I have made an initial assessment of the amended plans and they appear to show some positive changes but due to issues with their scaling, I am unable to make a detailed assessment.

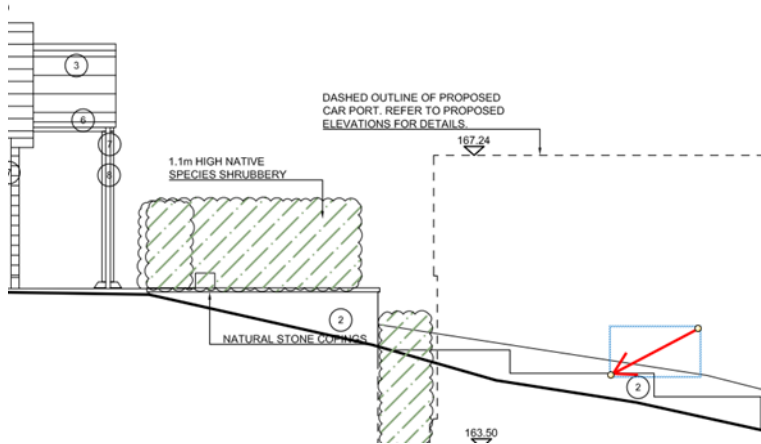
For example, for the proposed car port drawing (no. 52417-P-43 Rev. A) I have scaled off measurements at both 1:50 and 1:100 scale and my measurements are 4.7 metres (width) by 4.1 (depth) (measured from outside edge of the brick piers) or 9.4 metres (width) by 8.1 metres (depth) respectively. However, neither of these, match with the dimensions that you have referred to your email (6 metres by 5.2 metres). Furthermore, my measurements show a reduction in height of 0.5 metres for the car port and your email refers to 0.3 metres. **Our apologies for the confusion here – you were right to observe that specific drawing of the car port was neither 1:50 or 1:100 – somewhere inbetween and hence the confusion. I've updated the drawing to 1:100 so it aligns with the other elevation scales as attached.**
